**LETTER OF APPROVAL**

**RE: Project Name: The Cottages at Stonegate Ph 2  
County: Chatham  
Submitted by: Crowley and Associates, Inc.  
Date Received: 4/15/05; 4/29/05  
Date Processing Initiated: 4/15/05  
Watershed: Cape Fear #1/03-06-05  
New Submittal (X) Revised ( )**

### PLAN REVIEW COMMENTS

Figure 6.31c Finished riprap surface should blend with surrounding land surface.

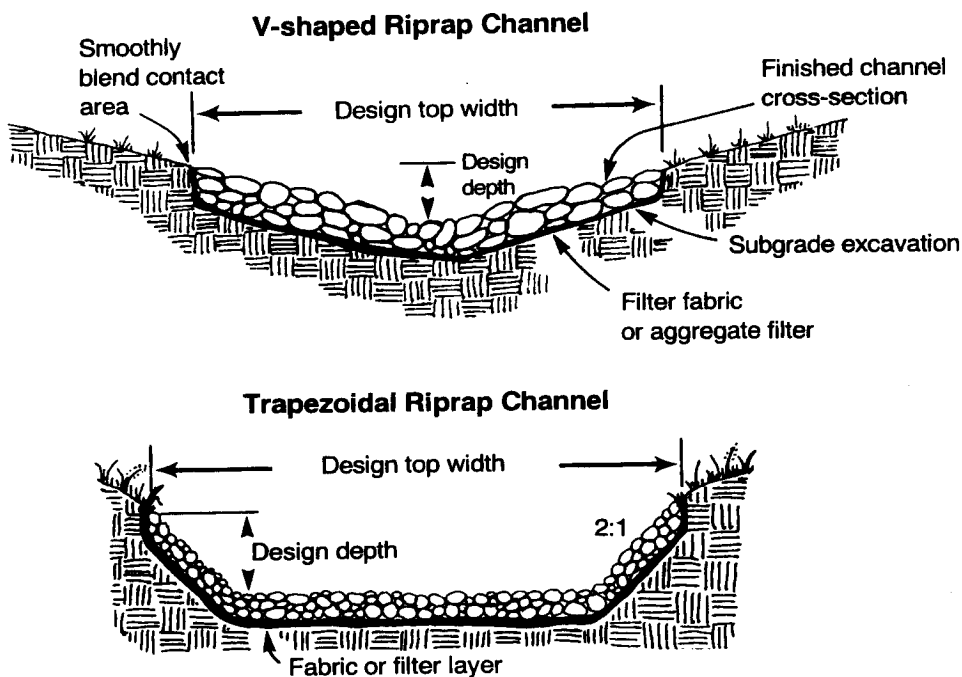
- 1)    Install rock check dams at outlet ditch #14 & #15.
- 2)    Class B rip rap in the above ditches must be at least 22" thick. Use the enclosed detail.

Blend the finished stone surface with surrounding land surface (Figure 6.31c). No overfall or channel constriction should exist. Grass-lined channels with riprap bottoms must have smooth contact between riprap and vegetation.
